**RE: Golf Course & Westside Commercial Development
Grading & Drainage Plans and Drainage Report
Engineer's Stamp Date: 03/29/23
Hydrology File: A12D008B2**

**RE: GOLF COURSE & WESTSIDE COMMERCIAL DEVELOPMENT
GRADING & DRAINAGE RESPONSE TO COMMENT**

Golf Course and Westside Commercial Development SE Corner of Golf Course Rd and Westside Blvd

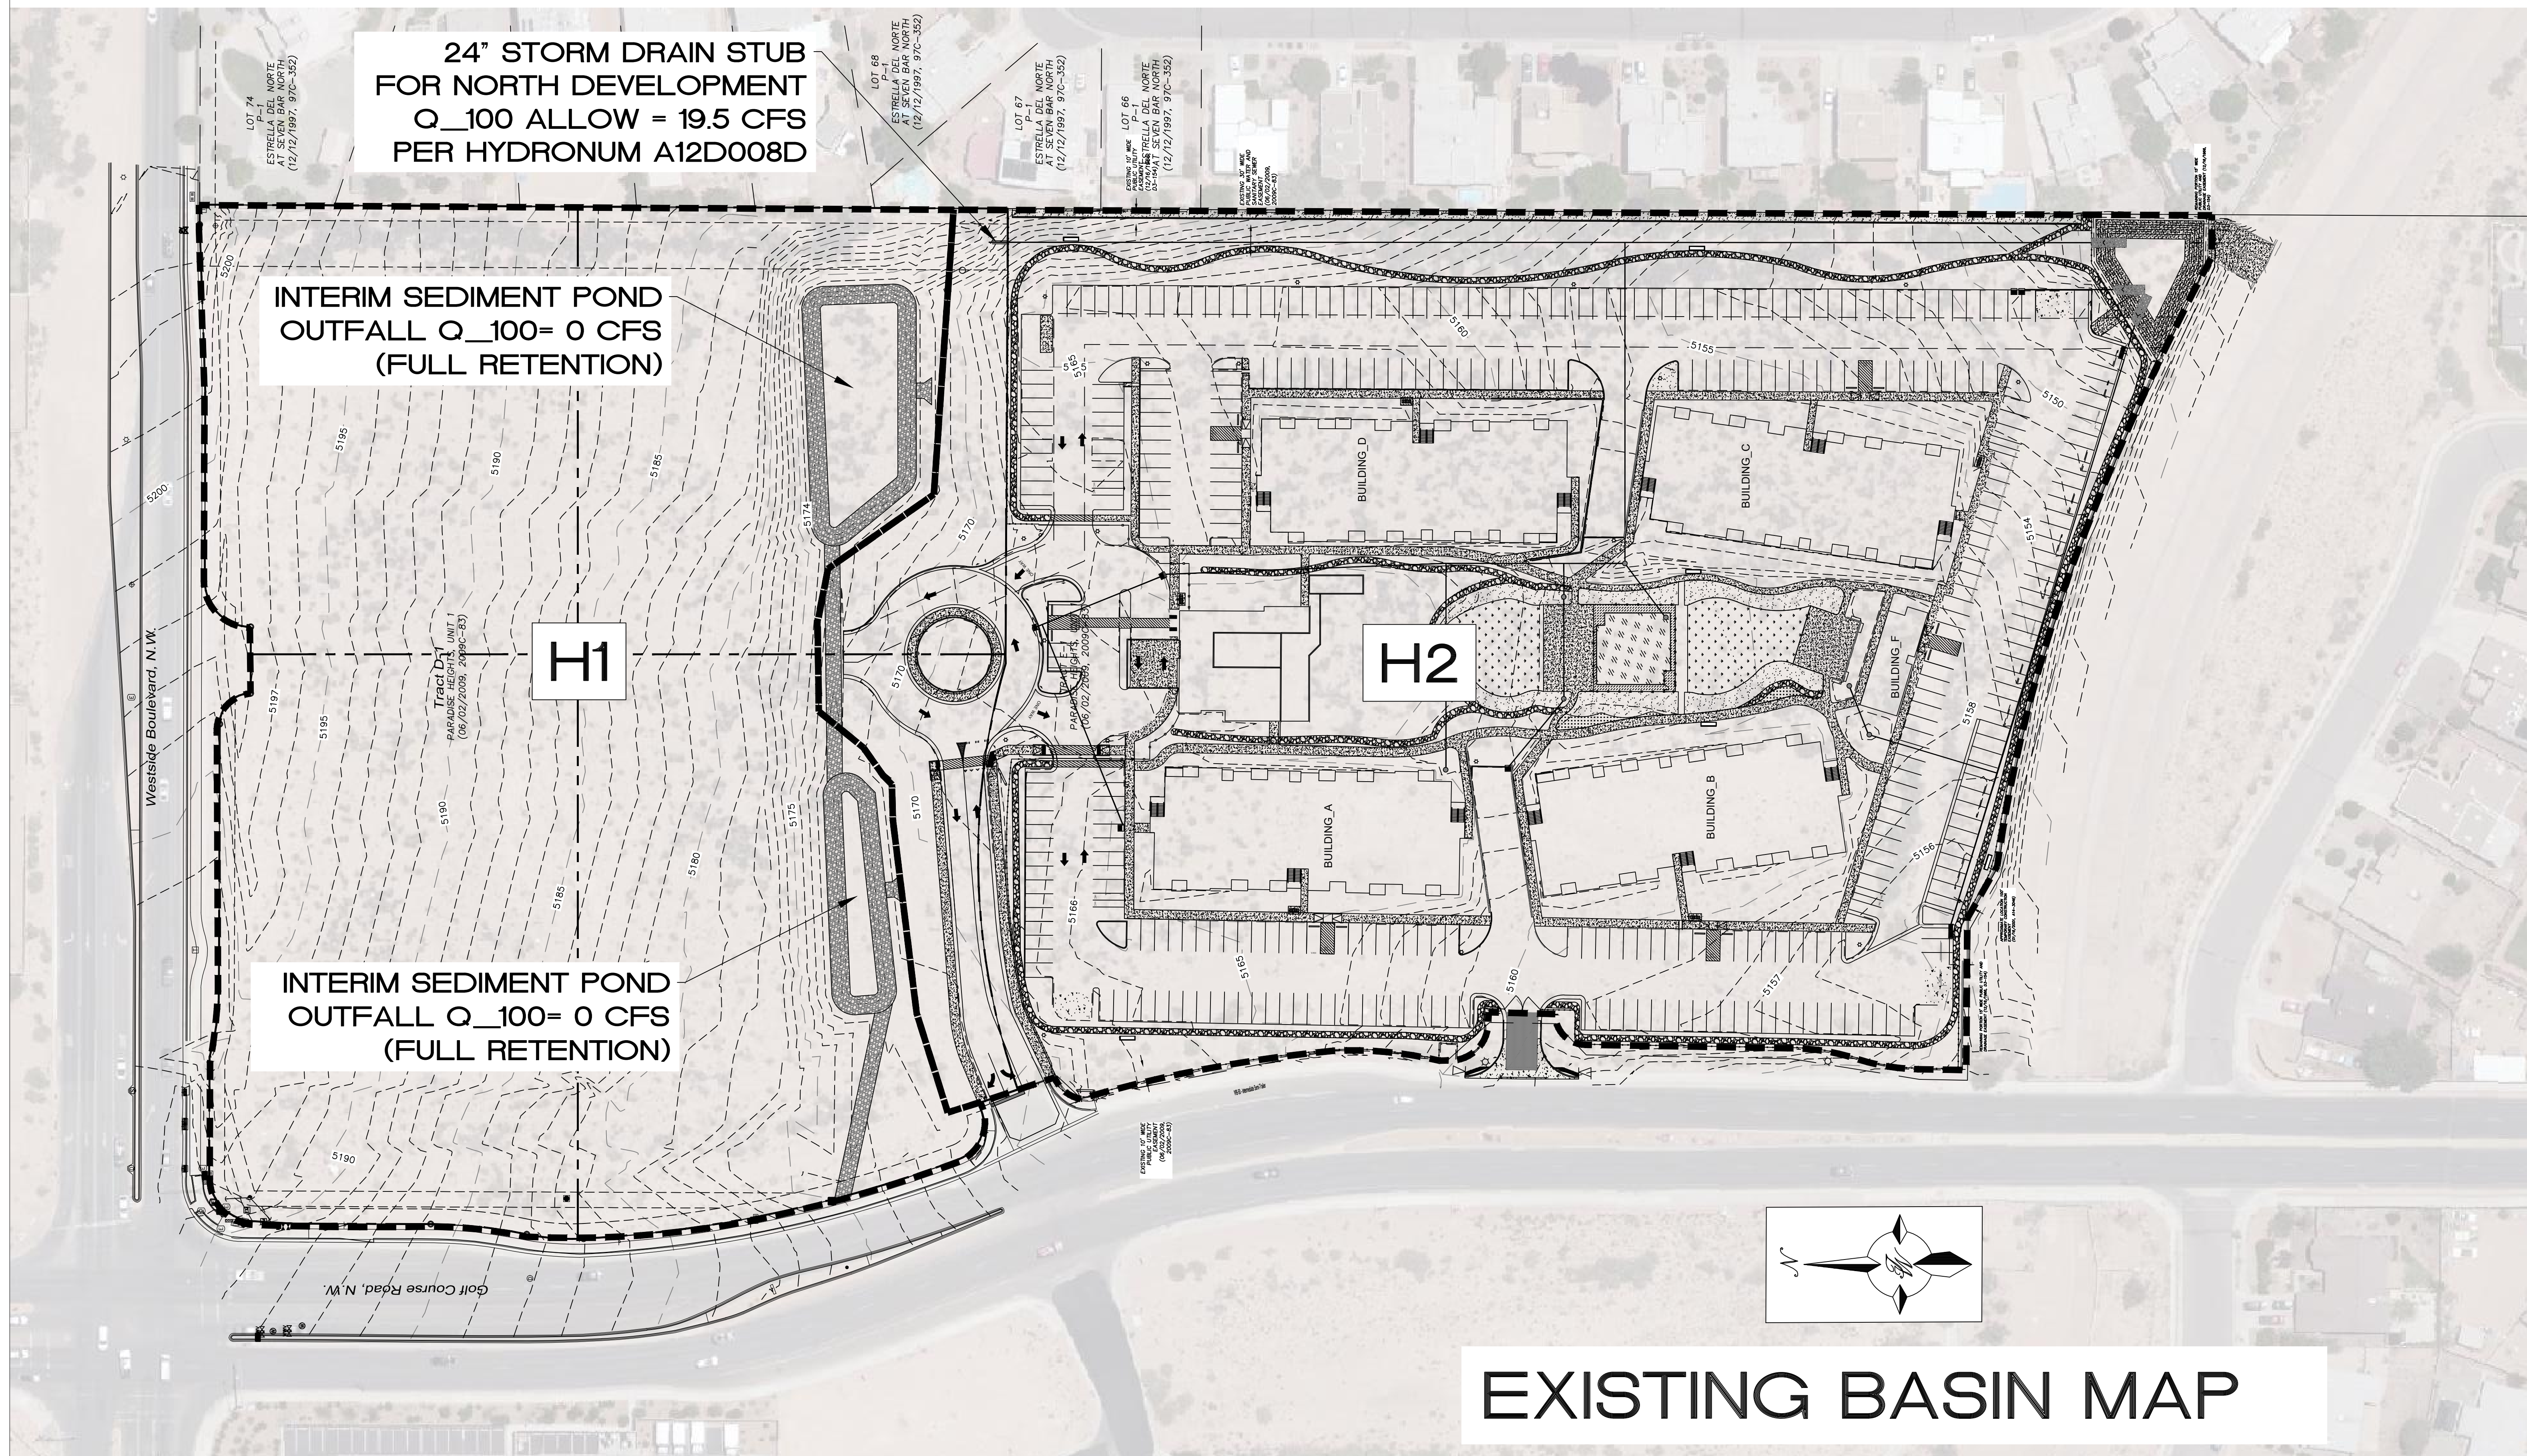
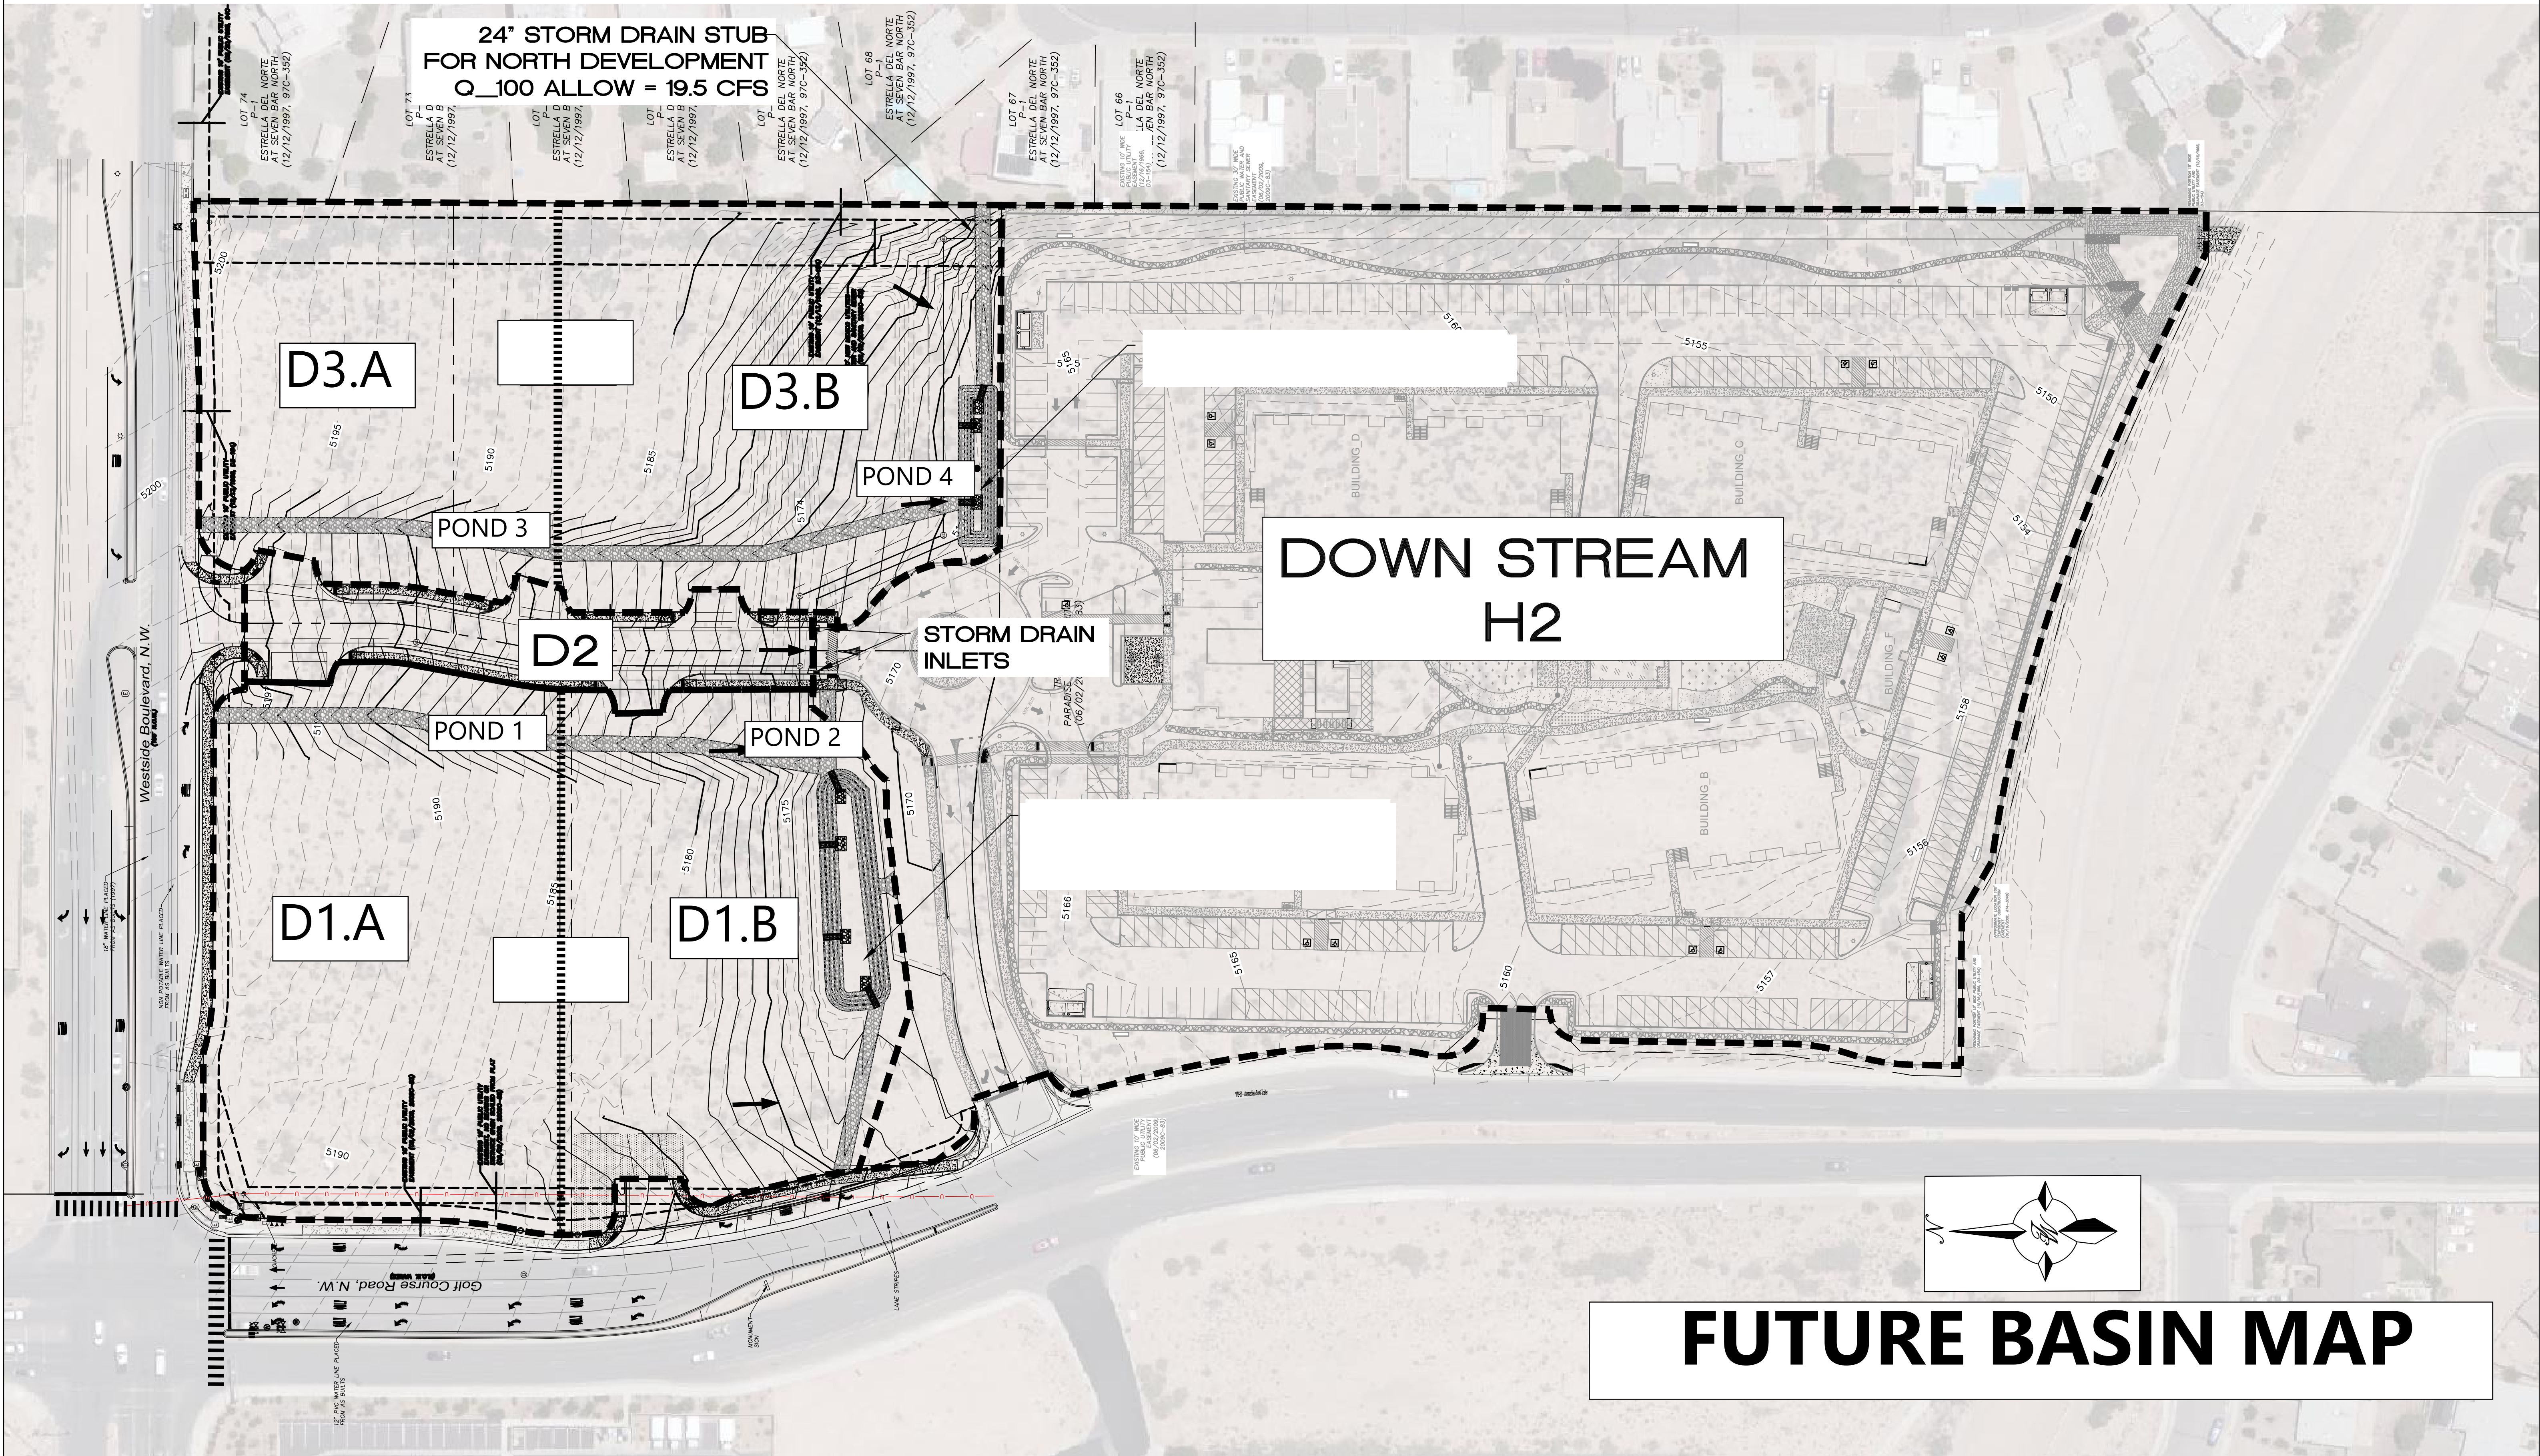
10. Future Conditions. Please include the future conditions for Drainage Area D3. This drainage are is missing in the calculations.

11. The AHYMMO calculations for the detention pond were only run for the proposed conditions and not the future conditions. Please run this for the future conditions to in sure that the allowable discharge is only 19.5 cfs and please show what the size of the detention pond would be for the future conditions.

Response: Please refer drainage report for updated Future Conditions sections in Appendix A of the report.

Response: Please refer drainage report for updated Future AHYMO input and output sections in Appendix A of the report.

CMP RISER DETAIL
NTS

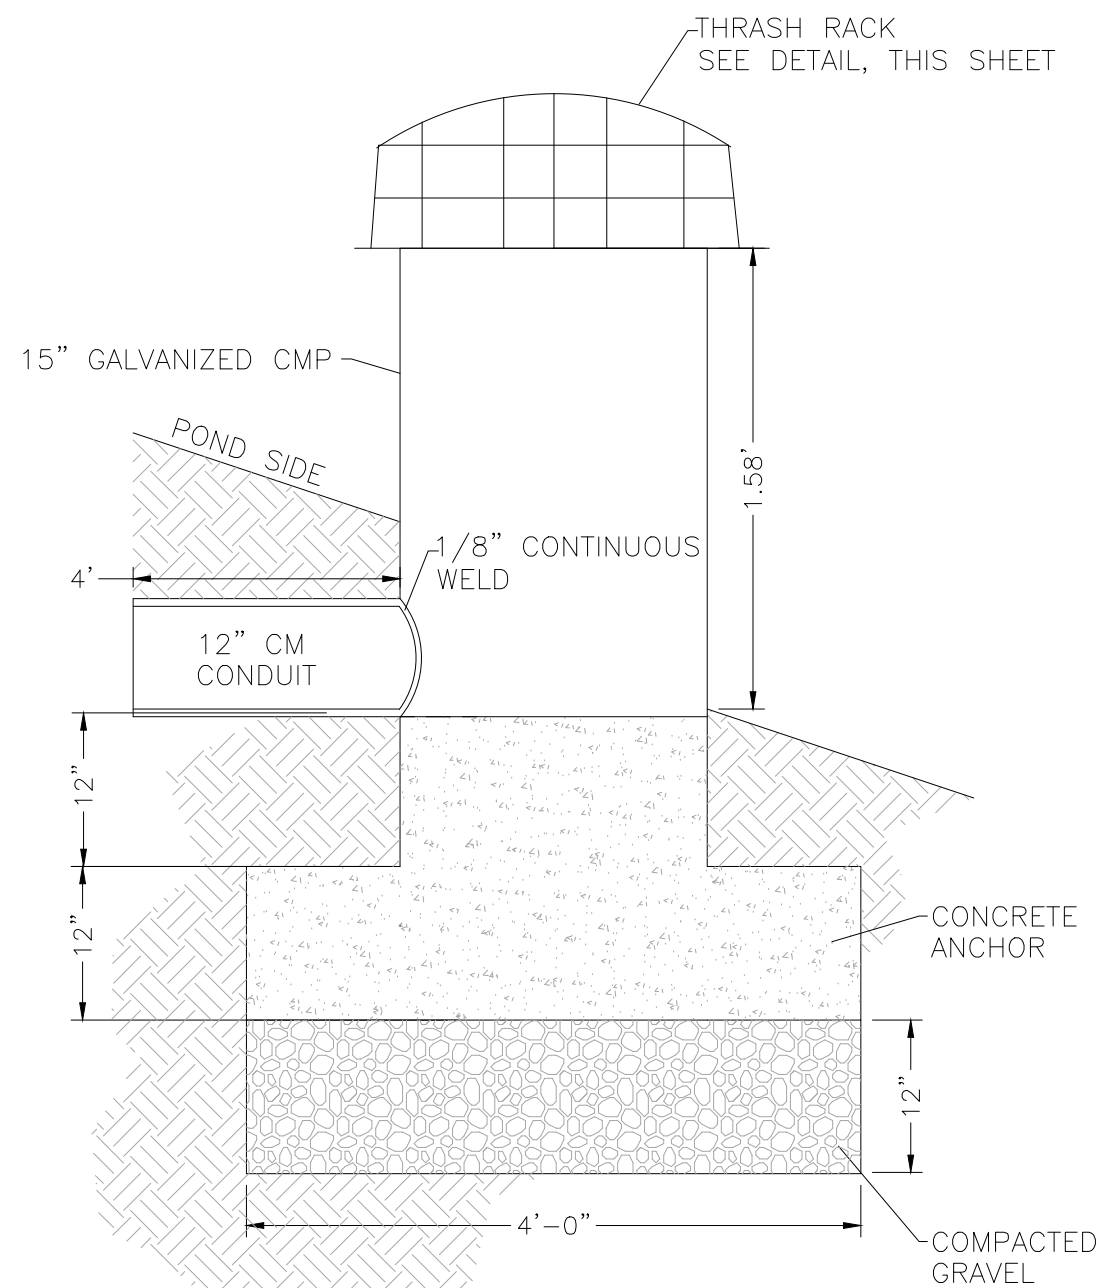
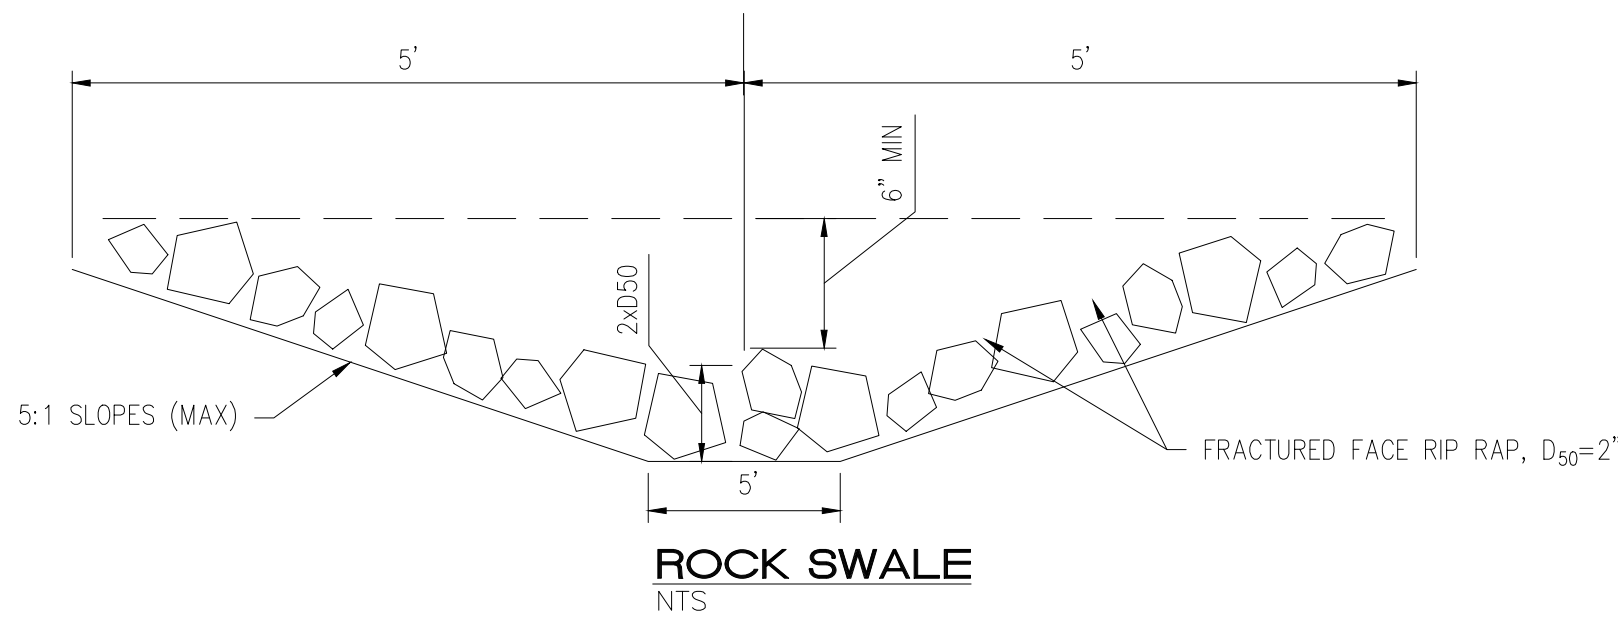
9. The proposed stand pipe will not function as shown. It needs to be at the bottom of the detention pond in order to work since the 1' dia holes will be drilled 360 degrees around the pipe. Also, the detail has information missing in order to build it as designed.

Response: The proposed stand pipe riser detail was updated to work under the specific site circumstances and constraints.
